Form 3160-5 (June 2019)

Update casing and cement program to current design.

Revised Permit Information 09/28/2023:

Well Name: Streetcar 15 Fed 208H

190' FSL Revised Wellbore A: KB: 3395' 470' FWL GL: 3370'

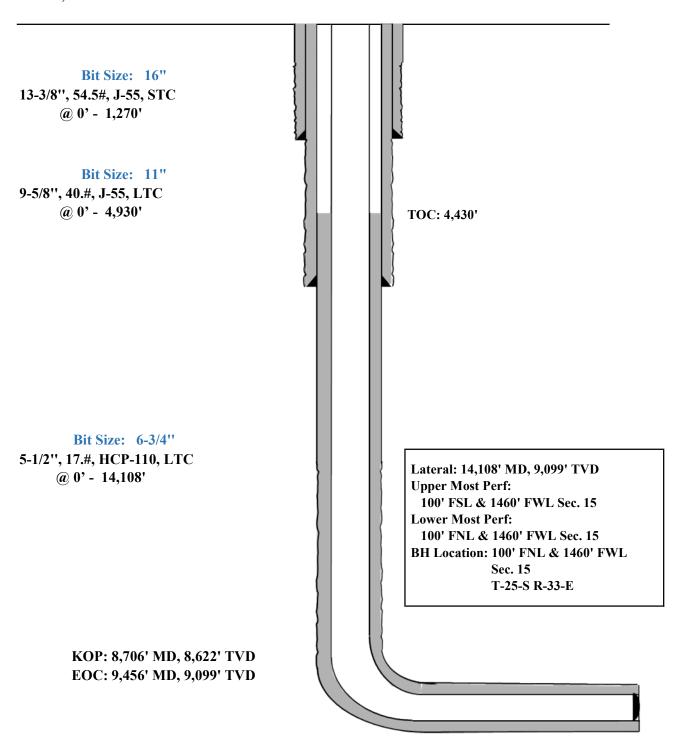
Casing Program A:

Hole	Interv	al MD	Interva	al TVD	Csg			
Size	From (ft)	To (ft)	From (ft)	To (ft)	OD	Weight	Grade	Conn
16"	0	1,270	0	1,270	13-3/8"	54.5#	J-55	STC
11"	0	5,019	0	4,930	9-5/8"	40#	J-55	LTC
6-3/4"	0	14,108	0	9,099	5-1/2"	17#	HCP-110	LTC

Variance is requested to waive the centralizer requirements for the 9-5/8" casing in the 11" hole size. An expansion additive will be utilized, in the cement slurry, for the entire length of the 11" hole interval to maximize cement bond and zonal isolation.

Variance is also requested to waive any centralizer requirements for the 5-1/2" casing in the 6-3/4" hole size. An expansion additive will be utilized, in the cement slurry, for the entire length of the 6-3/4" hole interval to maximize cement bond and zonal isolation.

EOG requests permission to allow deviation from the 0.422" annulus clearance requirement for the intermediate (salt) section from Onshore Order #2 under the following conditions:

190' Revised Wellbore B: KB: 3395' 470' GL: 3370'

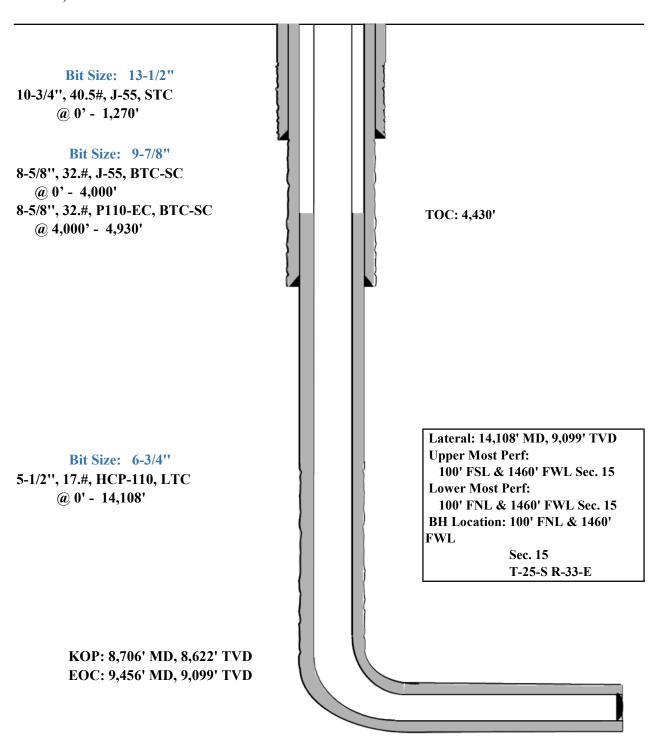
Casing Program B:

Hole	Interv	al MD	Interva	d TVD	Csg			
Size	From (ft)	To (ft)	From (ft)	To (ft)	OD	Weight	Grade	Conn
13-1/2"	0	1,270	0	1,270	10-3/4"	40.5#	J-55	STC
9-7/8"	0	4,088	0	4,000	8-5/8"	32#	J-55	BTC-SC
9-7/8"	4,088	5,018	4,000	4,930	8-5/8"	32#	P110-EC	BTC-SC
6-3/4"	0	14,108	0	9,099	5-1/2"	17#	HCP-110	LTC

Variance is requested to waive the centralizer requirements for the 8-5/8" casing in the 9-7/8" hole size. An expansion additive will be utilized, in the cement slurry, for the entire length of the 9-7/8" hole interval to maximize cement bond and zonal isolation.

Variance is also requested to waive any centralizer requirements for the 5-1/2" casing in the 6-3/4" hole size. An expansion additive will be utilized, in the cement slurry, for the entire length of the 6-3/4" hole interval to maximize cement bond and zonal isolation.

EOG requests permission to allow deviation from the 0.422" annulus clearance requirement for the intermediate (salt) section from Onshore Order #2 under the following conditions:

Design A

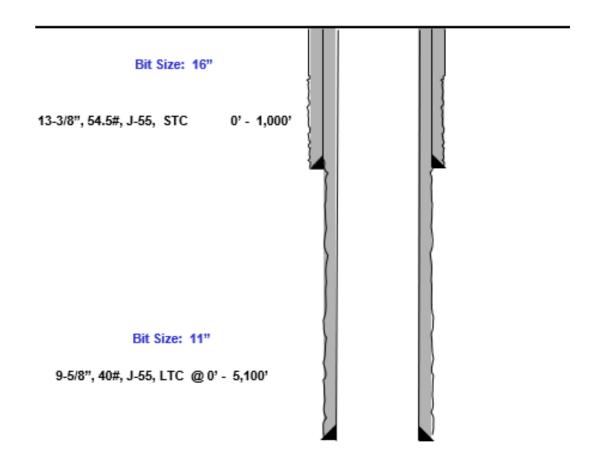
Proposed 11" Hole with 9.625" 40# J55/HCK55 LTC Casing

- 11" Bit + 0.52" Average hole enlargement = 11.52" Hole Size
 - 0.9475" Clearance to casing OD

• 0.4475" Clearance to coupling OD

- Previous Shoe 13.375" 54.5# J55 STC
 - 0.995" Clearance to coupling OD (~1,200' overlap)

Design B

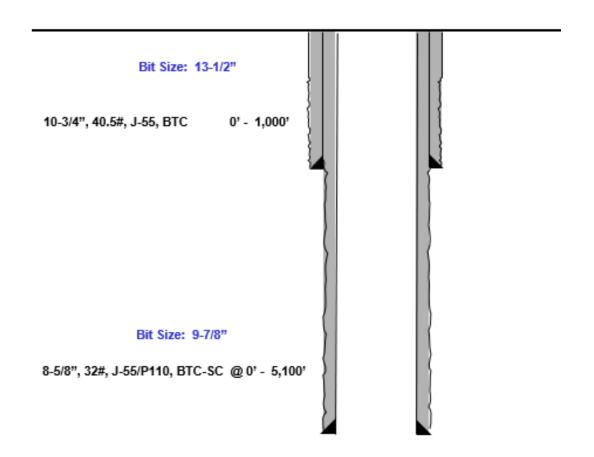
Proposed 9.875" Hole with 8.625" 32# J55/P110 BTC-SC Casing

- 9.875" Bit + 0.42" Average hole enlargement = 10.295" Hole Size
 - 0.835" Clearance to casing OD

• 0.585" Clearance to coupling OD

- Previous Shoe 10.75" 40.5# J55 STC
 - 0.4625" Clearance to coupling OD (~1,200' overlap)
